REMARKS

Application No. 08/000,000
 Amendment dated April 23, 2004
 Reply to Office Action of January 20, 2004
 ANNOTATED SHEET SHOWING CHANGES

FIG. 5

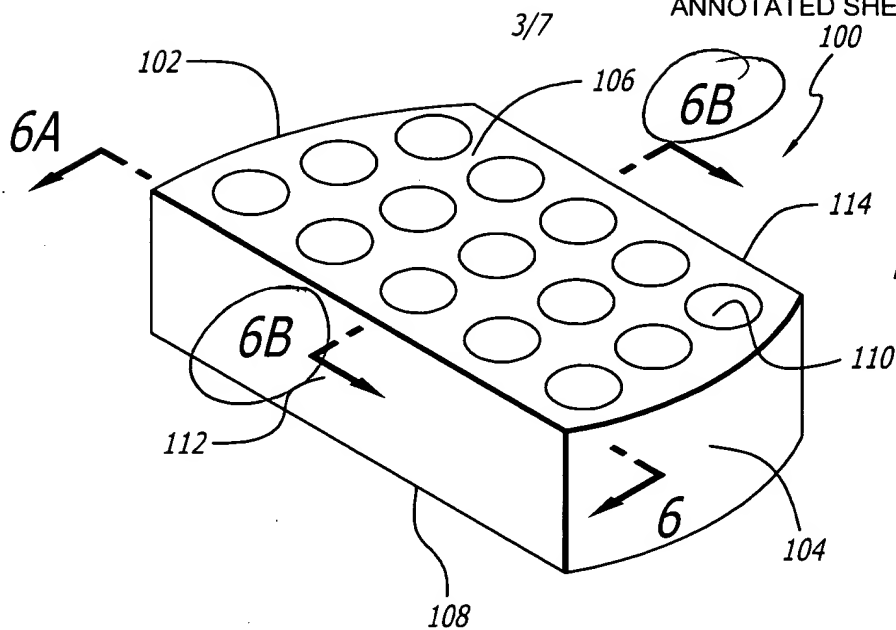
The Examiner contends that Figs. 5 and 6 show the implant to be solid between the openings. (Office Action, page 4, first paragraph). Applicant respectfully traverses the Examiner's contention. Fig. 6 shows a cross section of implant 100 taken through the thickness of the side wall between the top edge of side wall 112 and the leftmost column of openings 110. (See, e.g., Fig. 5). Fig. 6 shows the side wall of the implant with cross hatching to illustrate that the implant is made of an artificial material. (See specification, page 13, lines 8-18). Contrary to the Examiner's contention, Fig. 6 does not show that "the implant is solid between the openings" because as shown in Fig. 5, line 6--6 does not run between any of the openings.

FIG. 6B

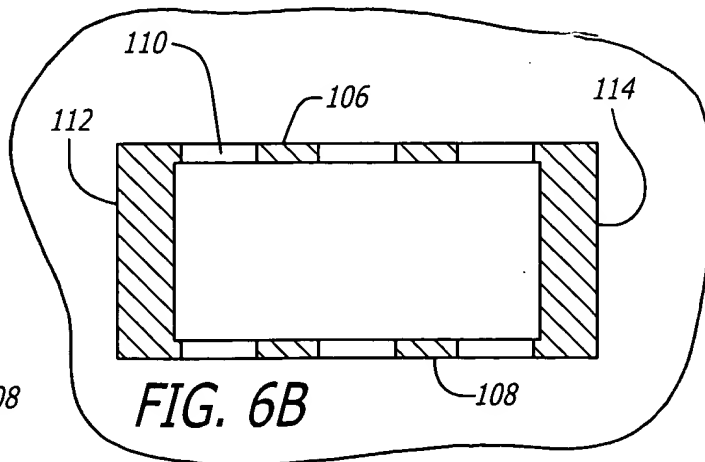
The Examiner objected to the drawings under 37 C.F.R. § 1.83(a) for not showing every feature of the claimed invention. In particular, the Examiner contends that the features "facing side walls," "inner surfaces facing each other," "hollow interior," and "first distance greater than the third" are not shown. Applicant respectfully traverses the Examiner's objection relative to the feature of "facing side walls." Fig. 9A (previously Fig. 9) shows an interior facing side wall 112 and an exterior facing side wall 114. (See, e.g., Specification, page 16, lines 15-17). For the other features noted by the Examiner, Applicant is submitting concurrently herewith a proposed drawing correction with new Figs. 6B and 9B. Fig. 6B is a cross section of Fig. 5 showing the side walls having an inner surface facing each other. Fig. 6B also shows the hollow interior of implant 100. Fig. 9B shows an implant where the first distance C is greater than the third distance A.

New Fig. 6B is supported by the language of claim 35 as originally filed, page 16, line 20 of the specification, and Fig. 5. New Fig. 9B is supported by the language of claim 2 as originally filed and page 17, lines 16-19 of the specification. No new matter has been added.

The Examiner rejected claims 1, 8, 9, 39, and 102-155 under 35 U.S.C. § 112, second paragraph, as being indefinite for failing to particularly point out and distinctly claim the subject matter which Applicant regards as the invention. For the Examiner's rejection of claim 1, a marked-up copy of Fig. 6B showing the features relating to the claim recitations not understood by the Examiner is attached hereto as Exhibit A. Applicant notes that independent claim 1 is the only independent claim reciting the
